Certified Action of the City of Raleigh Planning Commission

Case File / Name: SP-26-11 / ACC Auto Sales

Nature of Case: Construction of a 528 square foot, single-story retail auto sales office and associated display space on a .5 acre site zoned Neighborhood Business. This proposed retail development is within 400' of a residential use and zoning district.

Staff Report

SP-26-11 ACC Auto Sales – Site Plan

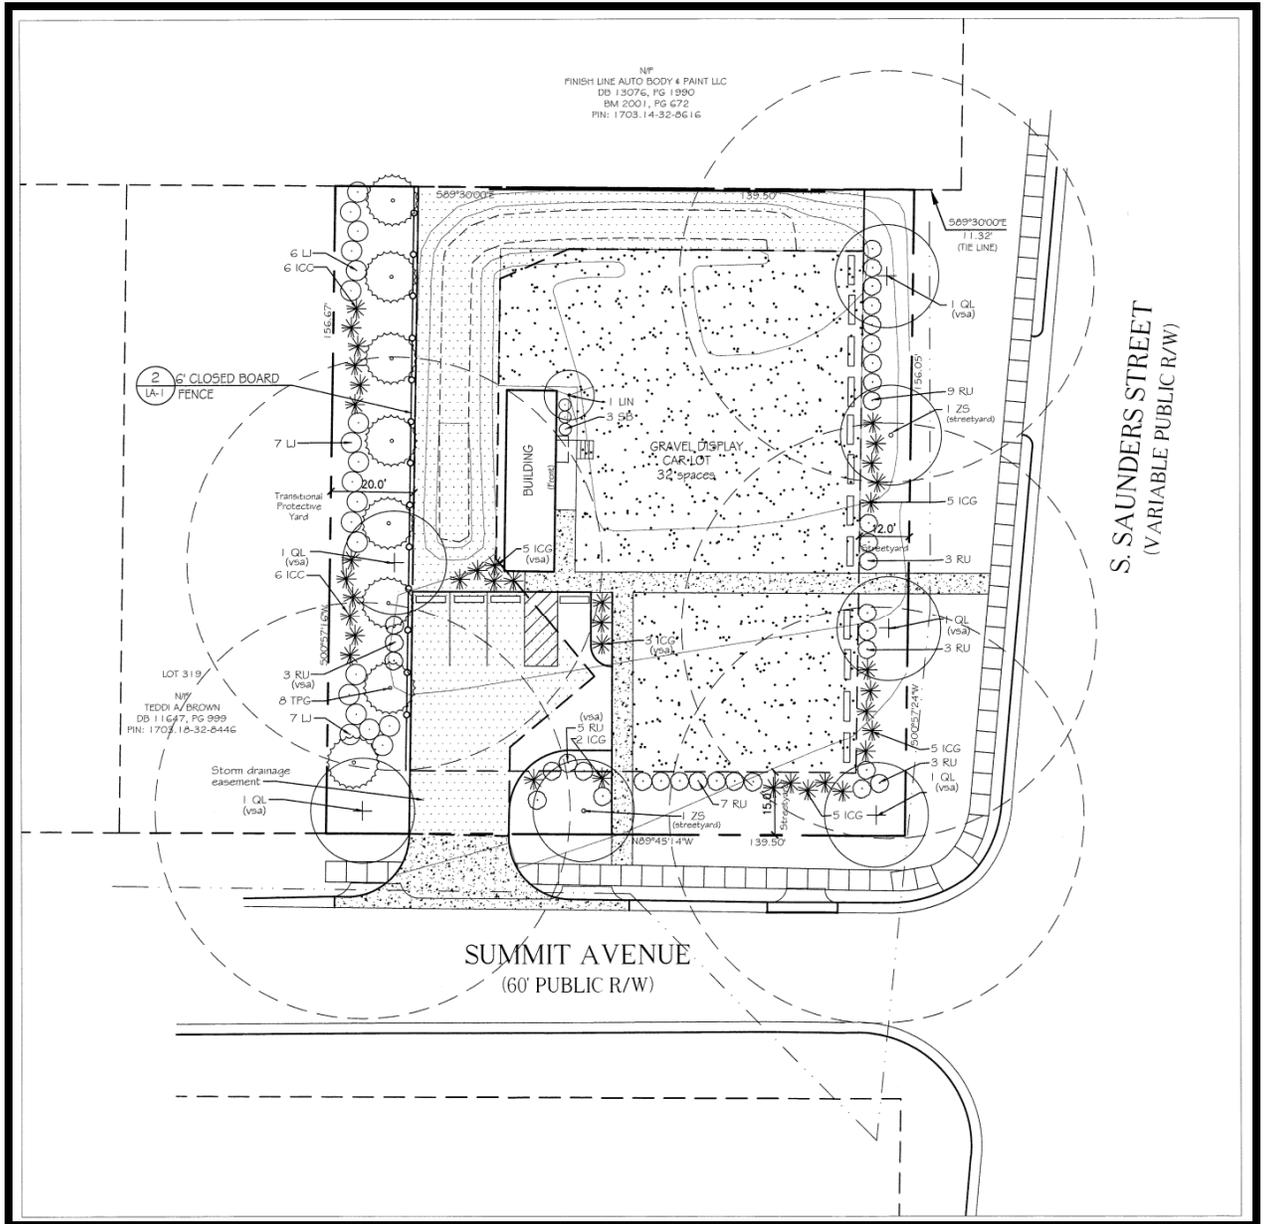
- (1) To improve the effectiveness of the transitional protective yard on the west boundary, the Planning Commission approved as an alternate means of compliance a five foot increase in width of the transitional protective yard and a five foot reduction for the street yard along South Saunders Street;

LANDSCAPING: Street yard landscaping of seven feet in width was approved by the Planning Commission as an alternate means of compliance. Vehicular surface area landscaping in conformity with Section 10-2082.6 is shown. This is a high impact use under Section 10-2082.9. Transitional protective yards are shown in compliance with City standards in the following locations:

* A high impact use adjacent to low density residential requires a 40' Type A transitional protective yard. Code Section 10-2082.9(g)(3)(d) allows a closed fence to be used to meet the requirements of 10-2082.9.

* Code Section 10-2082.9(g)(3) if a closed fence is erected pursuant to 10-2082.9(g)(1)(e) the width of the transitional protective yard may be reduced by ½. The Planning Commission approved an alternate means of compliance by adding additional five feet in width to the transitional protective yard and reducing the street yard width along South Saunders Street by five feet.

<u>Comment</u>	<u>Response</u>
The committee also recommends that, as maples often struggle in urban environments, oaks be substituted as streetyard plantings	Overcup Oaks have replaced the maples on the landscape plan.
The building and handicap ramp be visually anchored through installation of landscaping, including ornamental understory trees (e.g., crape myrtle) as corner accents.	A landscaped area with a Crape Myrtle and Spireas were added in front of the building adjacent to the handicap ramp.
All gravel areas be given a hard edge so that spillover into grassy areas is minimized.	Landscape timbers will be installed on perimeter of gravel parking areas.
The building be given a solid (e.g., brick veneer over block) foundation, and the handicap ramp also be finished underneath (e.g., boxed with a solid wood enclosure or masonry wall).	Crape myrtle corner accent has been shown on the landscape plan.

The building include a roof extension or canopy protecting the entrance and upper handicap ramp.	Canopy has been added to building entrance.
The railing on the handicap ramp be of finished metal, not pressure-treated wood.	The h/c ramp will be finished with a metal railing.
